PREVOST

WARRANTY BULLETIN

WB15-53A

DATE :	NOVEMBER 2015	SECTION :	04 - Exhaust
EXPIRATION:	NOVEMBER 2017		
SUBJECT :	DIESEL PARTICULATE FILTER (DPF) – LOOSE PLUGS

FIRST PLUG

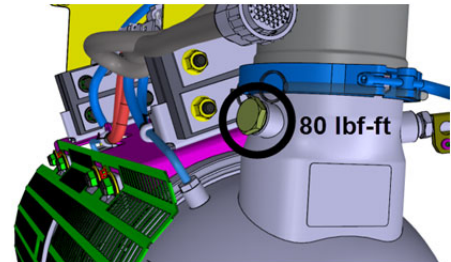
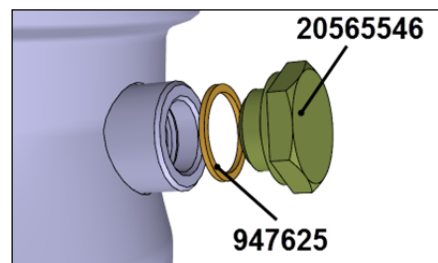
On the vehicles covered by this bulletin, two DPF (diesel particulate filter) plugs may be loose. If a plug is loose, it may fall out under the effect of vibration. This may cause leakage of hot exhaust gases.

1. Check if the M20 hexagonal plug located to the right side of the DPF (see image at right) is properly tightened.

2. Apply a torque of **80 lbf - ft**.

If the plug is missing, order plug #20565546 and copper seal #947625.

SECOND PLUG

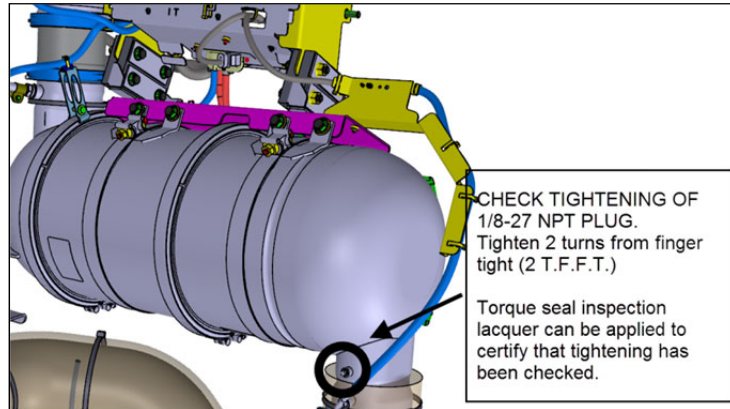
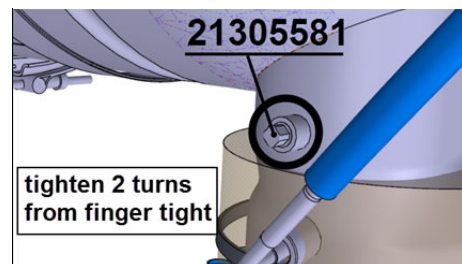
1. Check if the 1/8-27 NPT plug located to the left side of the DPF (at the inlet of DPF) is properly tightened.

2. Tighten 2 turns from finger tight (2 T.F.F.T.).

If the plug is missing, order plug #21305581.
